## Land at Gosford

### Technical Note 13: Response to Active Travel England (ATE)

14<sup>th</sup> August 2023

Status		Status Date
Information		Feb 2022
Drawn	Checked	Date
HG	AE	22.02.22
Scale	Number	Rev
As shown	10669-SK-05	F
0 10 20 30 40 50		
METRES

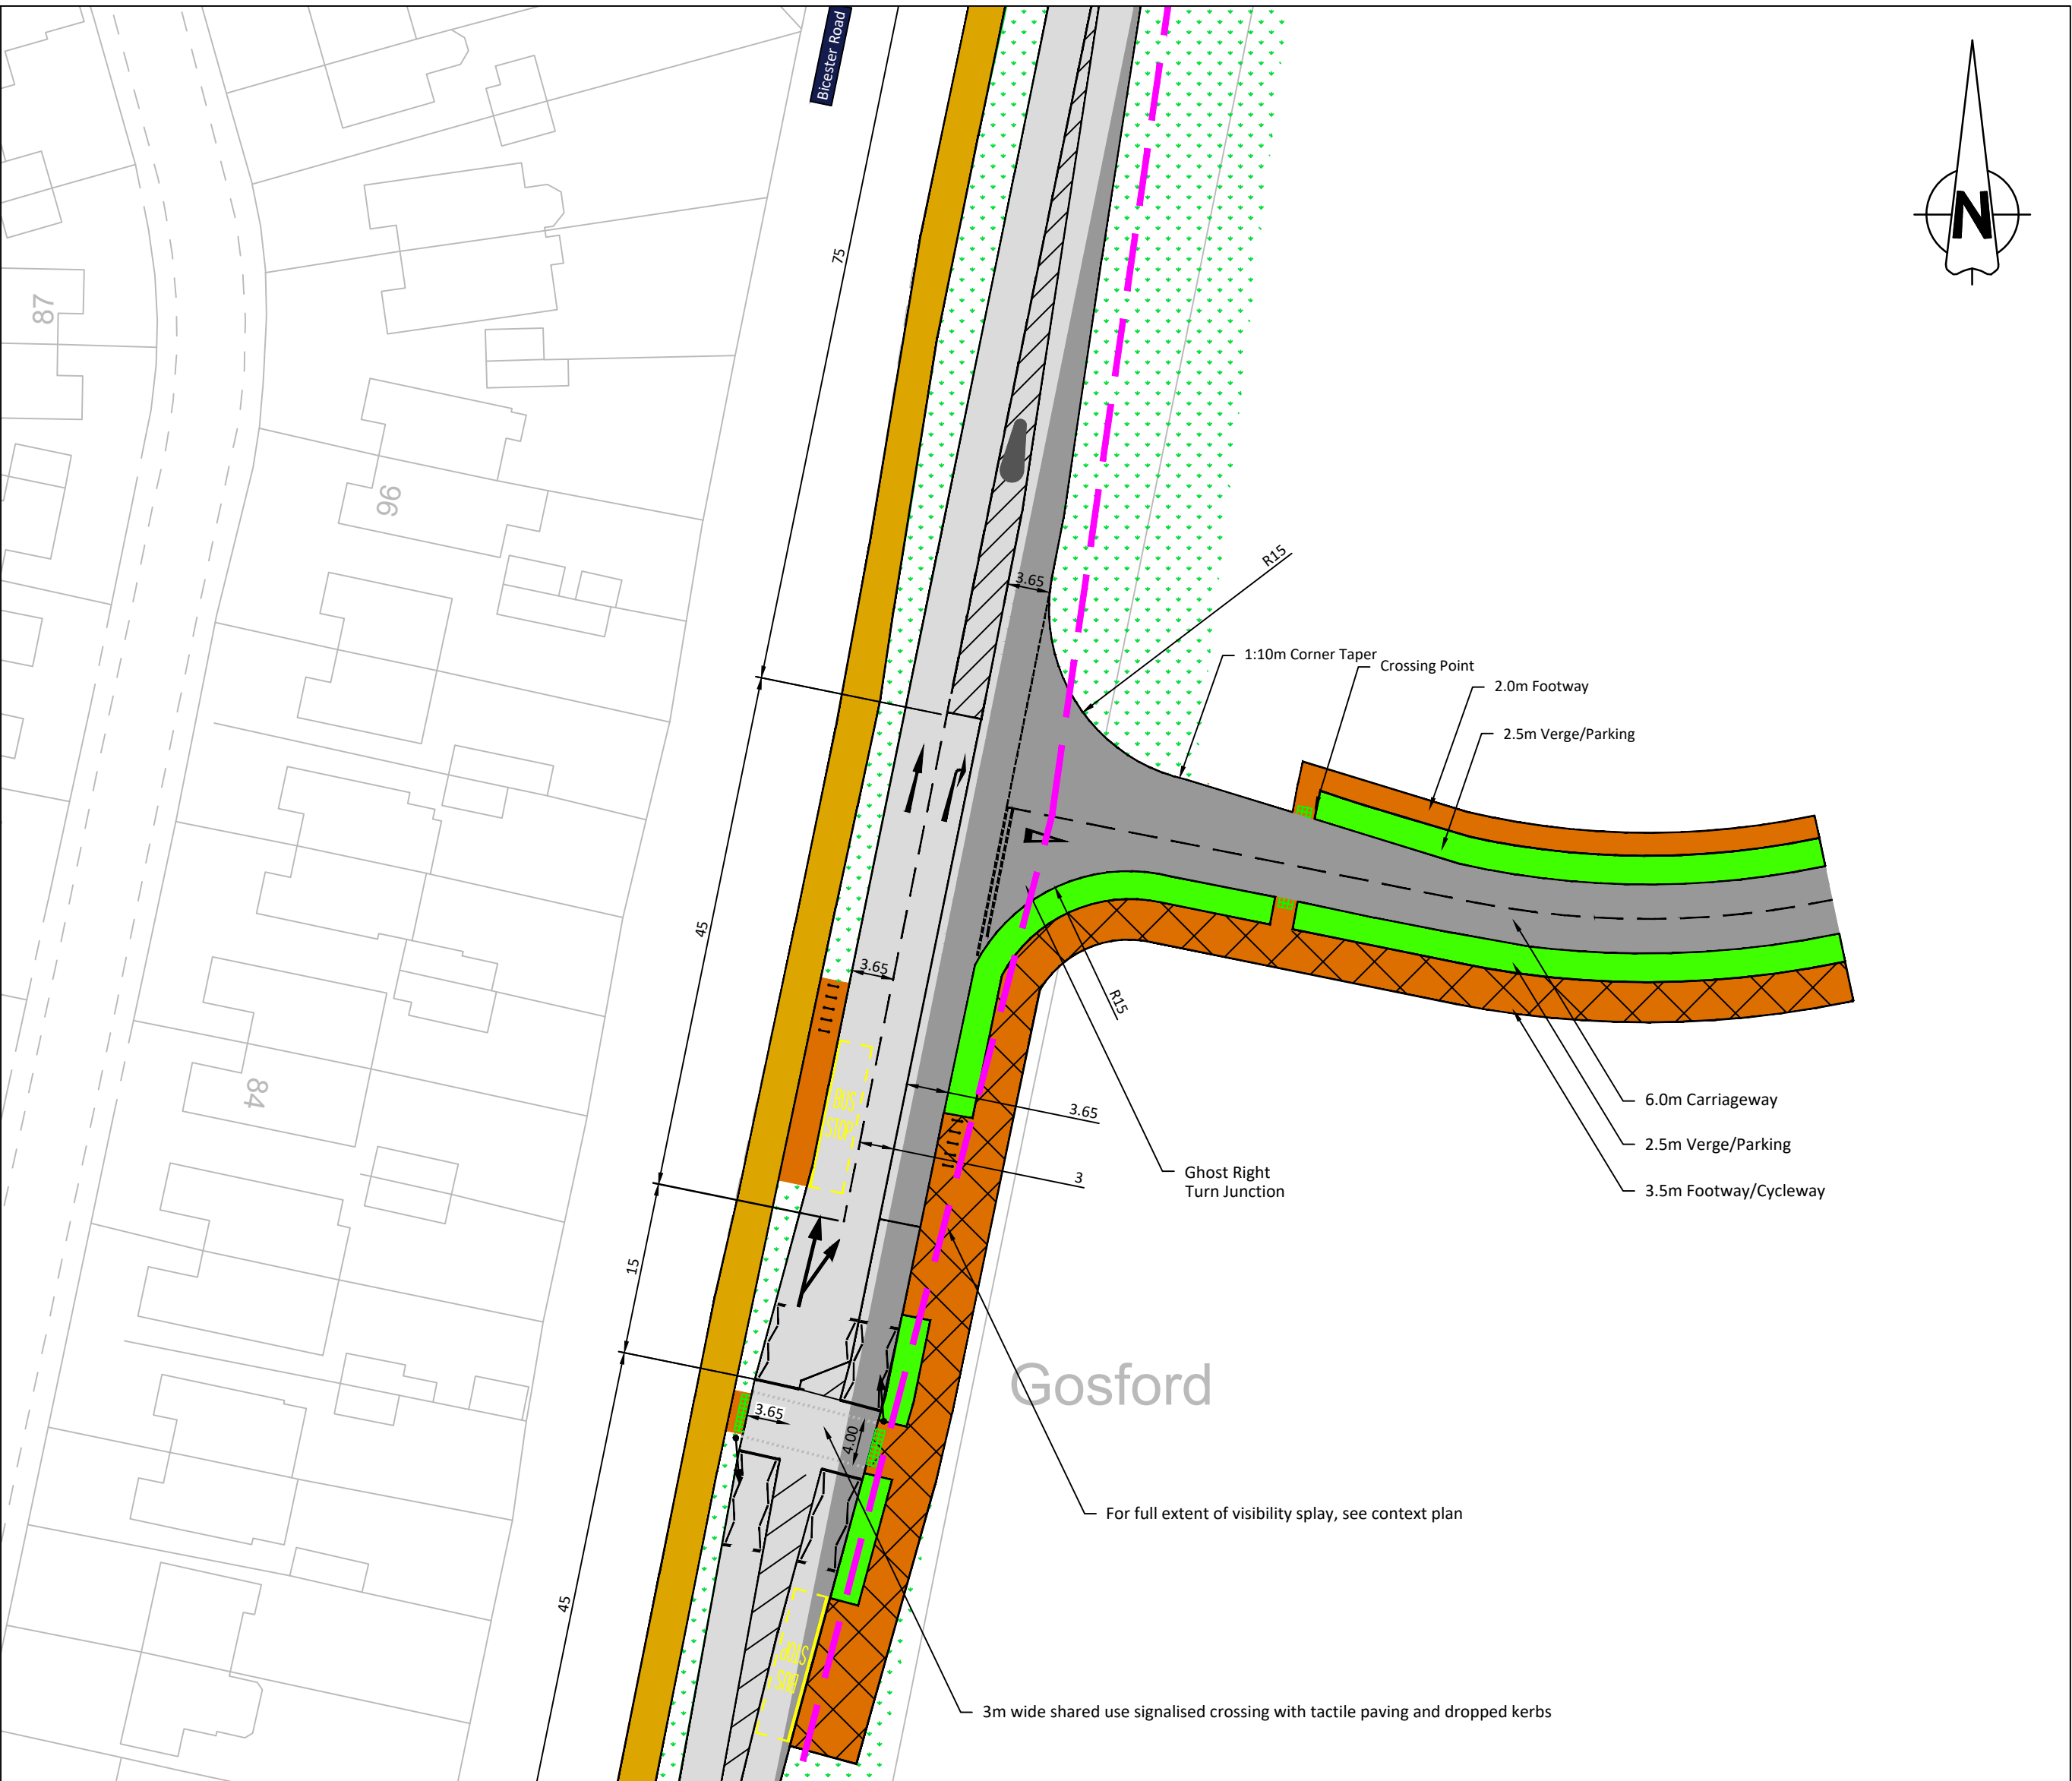
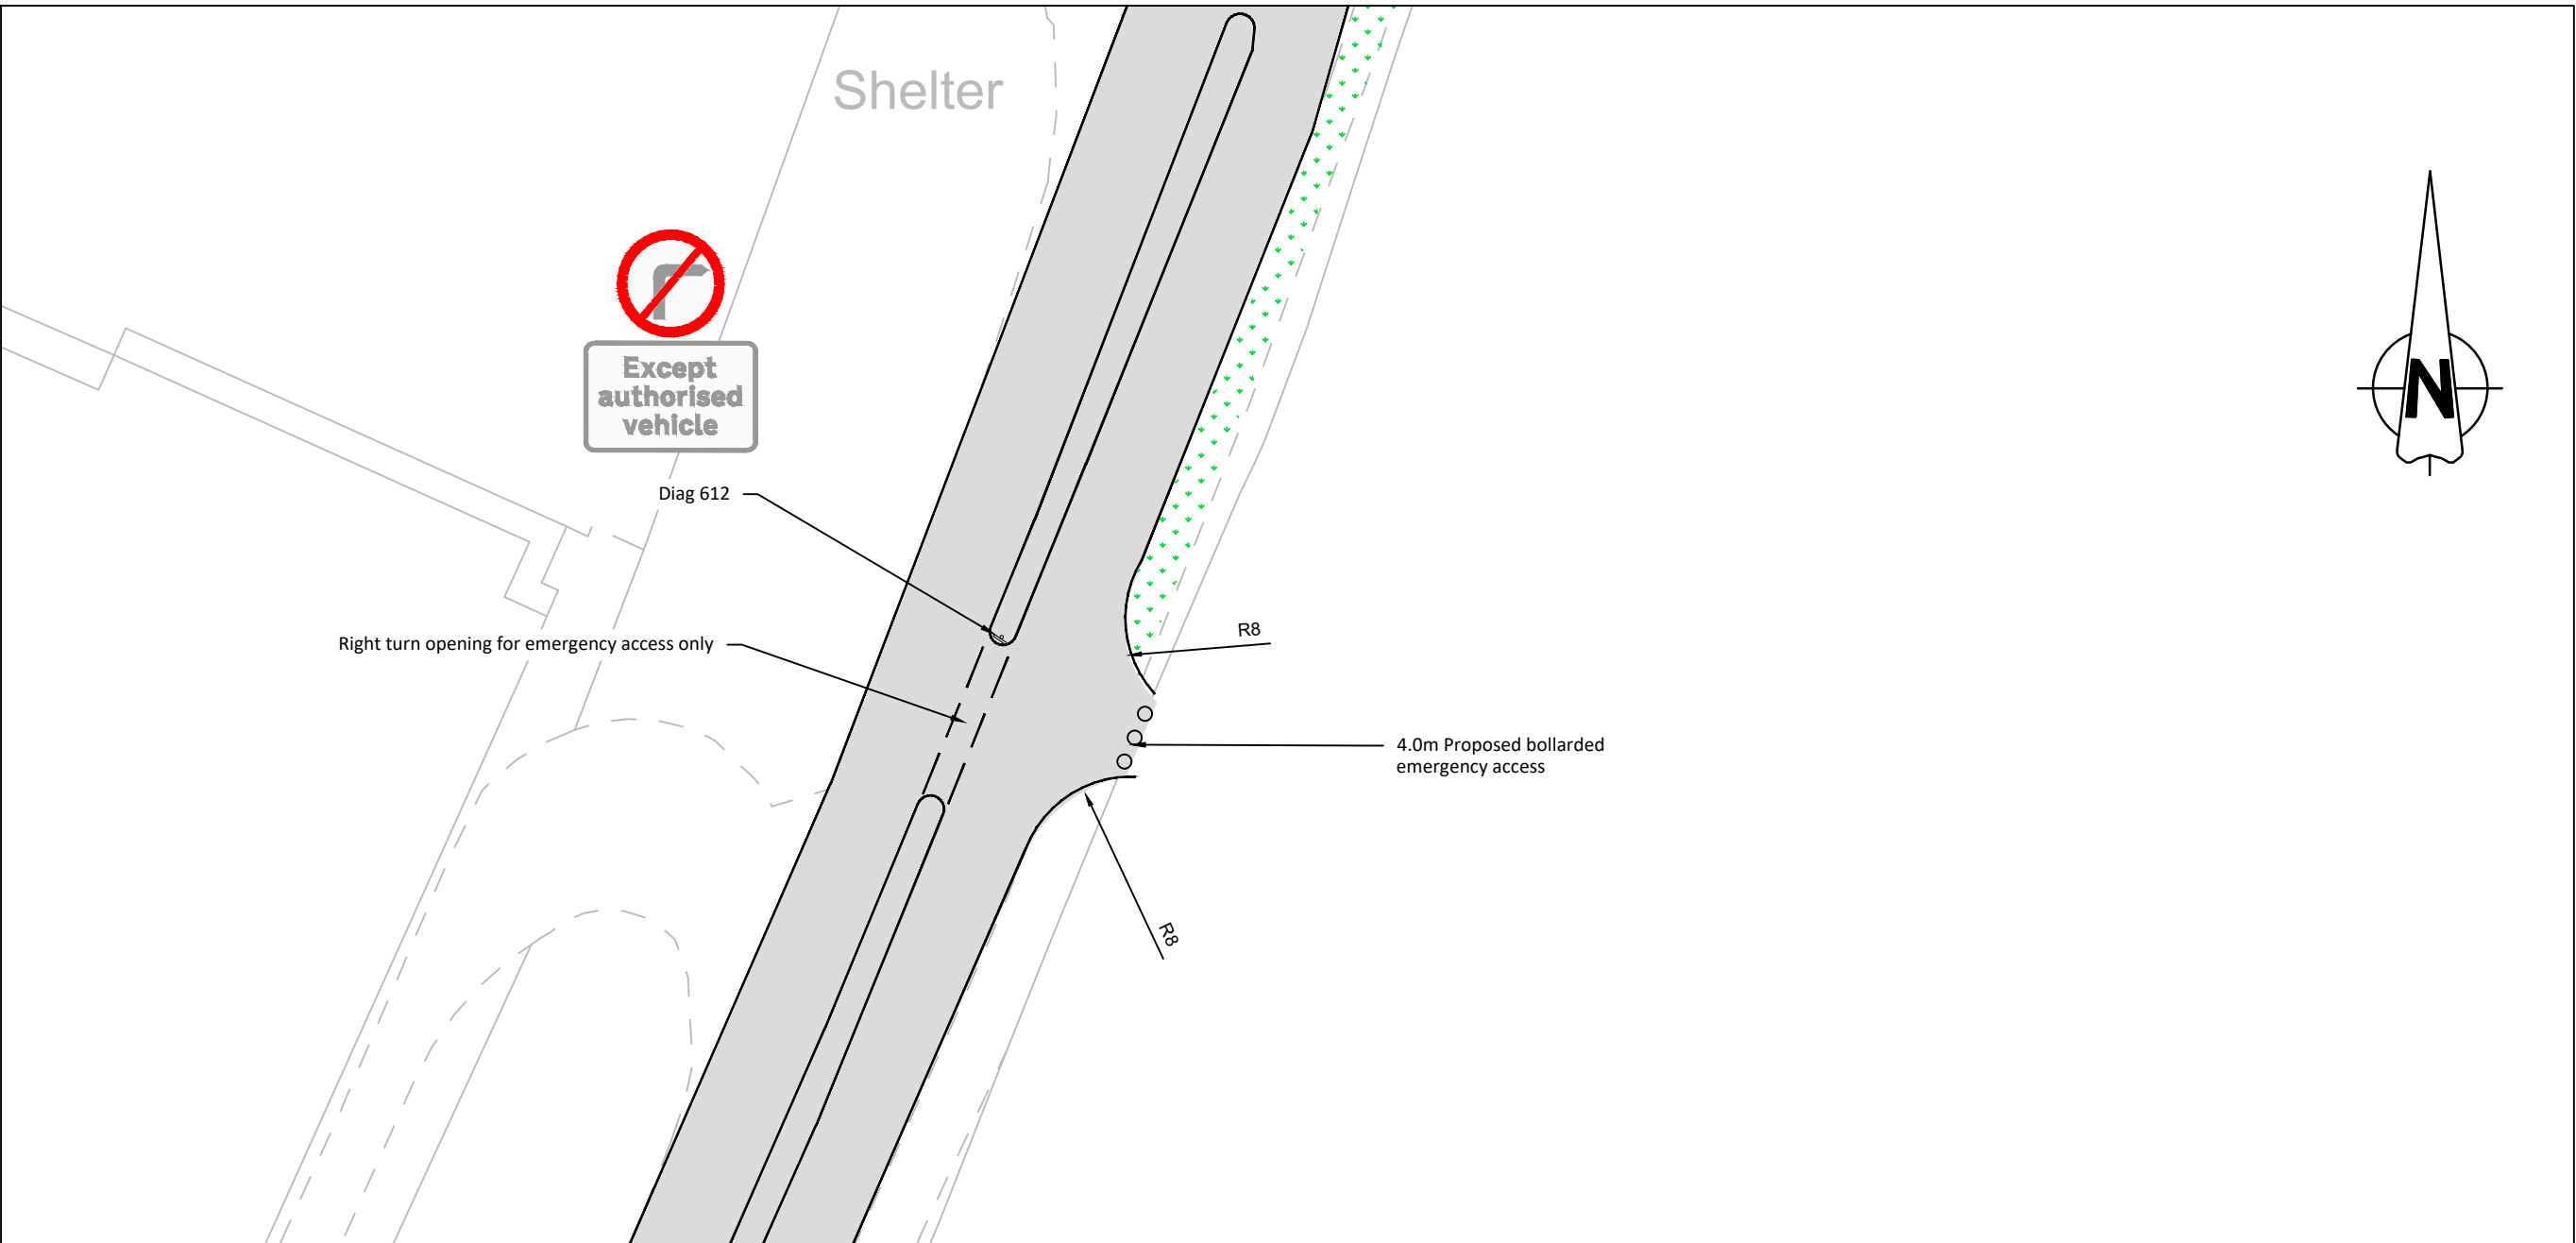
*ATE Comment: ATE notes that the pedestrian and cycle movements would be catered for through on and off-carriageway provision. However, the segregation provided to walkers, wheelers and cyclists is not clear. Bicester Road is currently limited to a single shared footway/cycleway on its western side. It requires users to cross the carriageway whether they are travelling north into Kidlington or South into Oxford. It is noted from the Transport Assessment that crossing points are to be provided across Bicester Road to access the existing footway/cycleway, and the location of a crossing is shown on drawing 10669-SK-05 included in the Transport Assessment, but the type of crossing is not specified. This design requires further consideration in accordance with LTN1/20.*

*ATE Comment: In accordance with paragraph 104 of the NPPF, Active Travel England notes the location of the proposed pedestrian crossing in the Transport Assessment (drawing 10669-SK05) and would welcome further detail on the type of crossing to ensure its suitability for all users.*

- 3.3 The connections along Bicester Road have also been raised by OCC. The access drawing has subsequently been updated, 10669-SK-05F, which confirms that the crossings along Bicester Road will be signalised, as confirmed in paragraph 3.7 of 10669TNH11vRev1. The amended site access drawing is contained in **Appendix A**. A Road Safety Audit has been completed that reviewed the site access arrangements with the full details provided within the TA Addendum.

- 3.9** As previously indicated, crossing facilities along Bicester Road are to be delivered. These are to be signalised crossing points which complies to LTN 1/20. These are indicated on the site access drawing 10669-SK-05F, which is contained in **Appendix A**.

- 3.10** As previously indicated, the crossing facilities along Bicester Road are to be signalised. These are indicated on the site access drawing 10669-SK-05F which is contained in **Appendix A**.
